Service Bulletin

Bulletin No.: 18-NA-069

Subject: Poor Engine Performance in Extremely Cold Weather Conditions for LFV Engines, Charge Air Cooler Icing - Malfunction Indicator Lamp (MIL) Illuminated, DTC P0299, P0236, P2227, P00C7 Set

Brand:	Model:	Model Year:		VIN:		Engine:	Transmission:
		from	to	from	to		
Chevrolet	Malibu	2016	2019			1.5L (LFV)

4241877

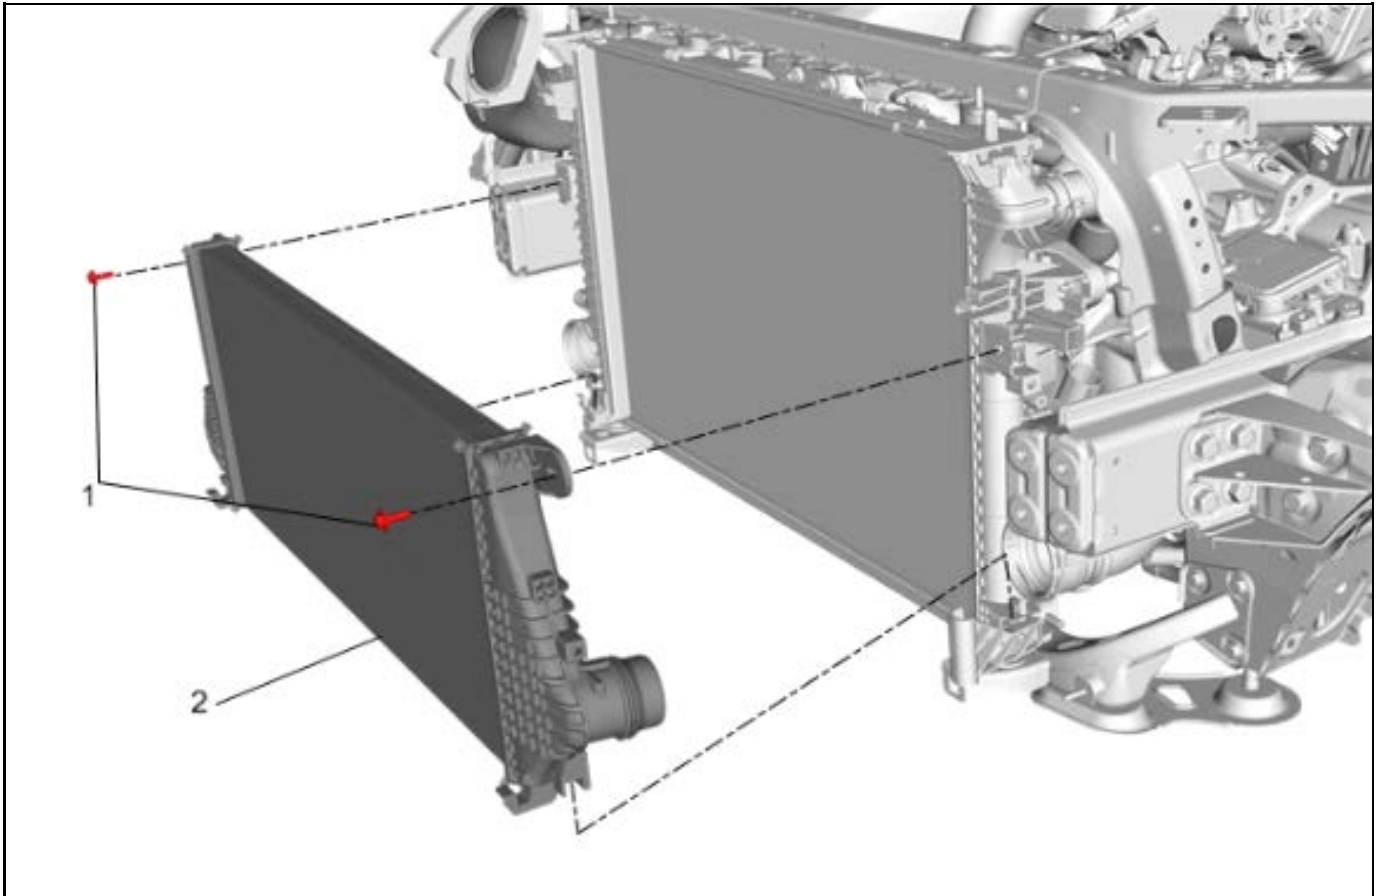
1. Install the CAC (2). Refer to *Charge Air Cooler Replacement* in SI.

4233269

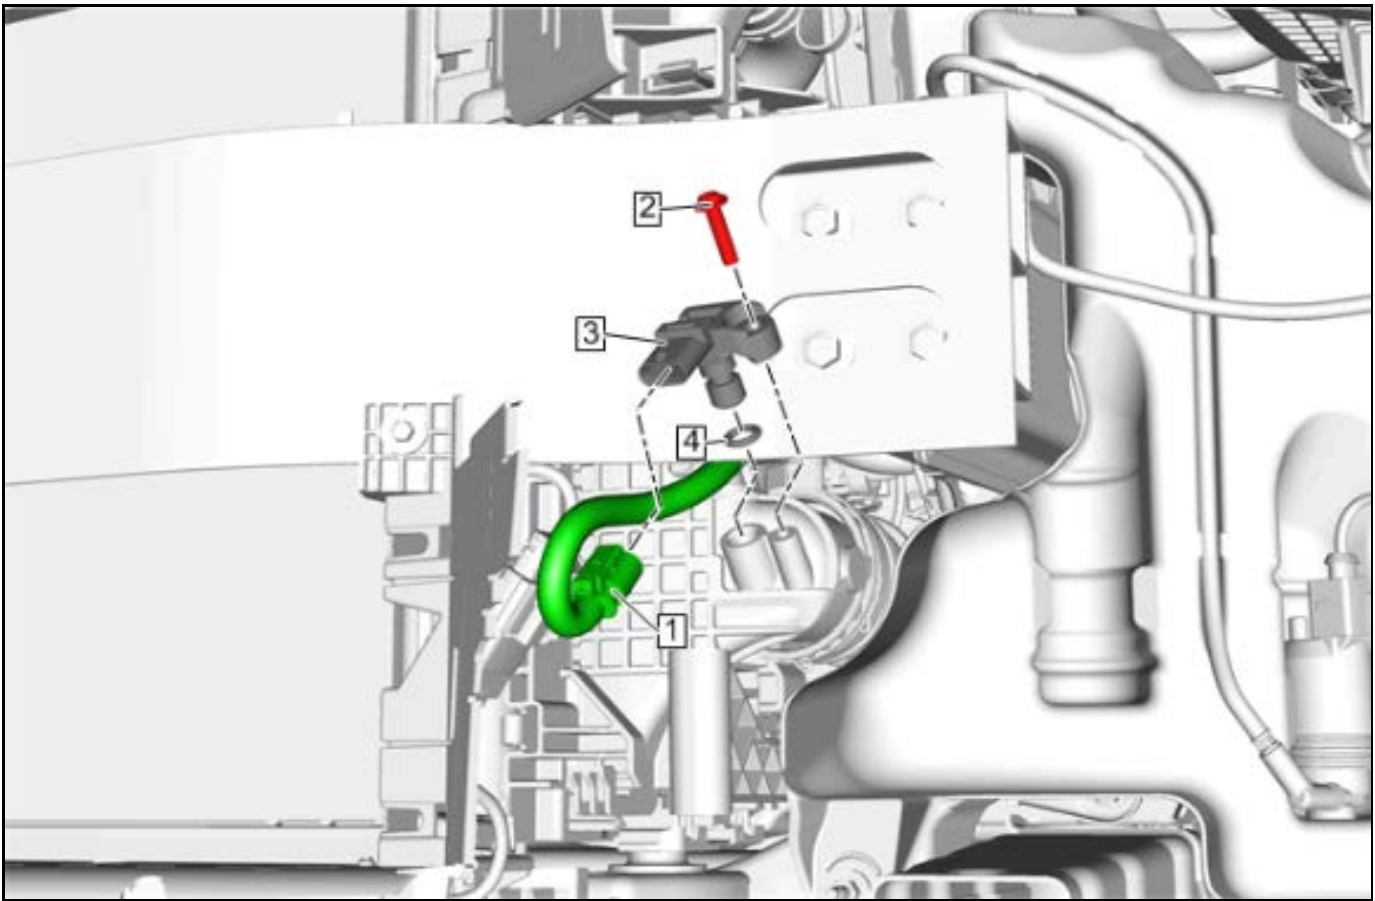
3. Remove the Turbocharger Air Pressure sensor (3). Refer to *Turbocharger Air Pressure Sensor Replacement* in SI.
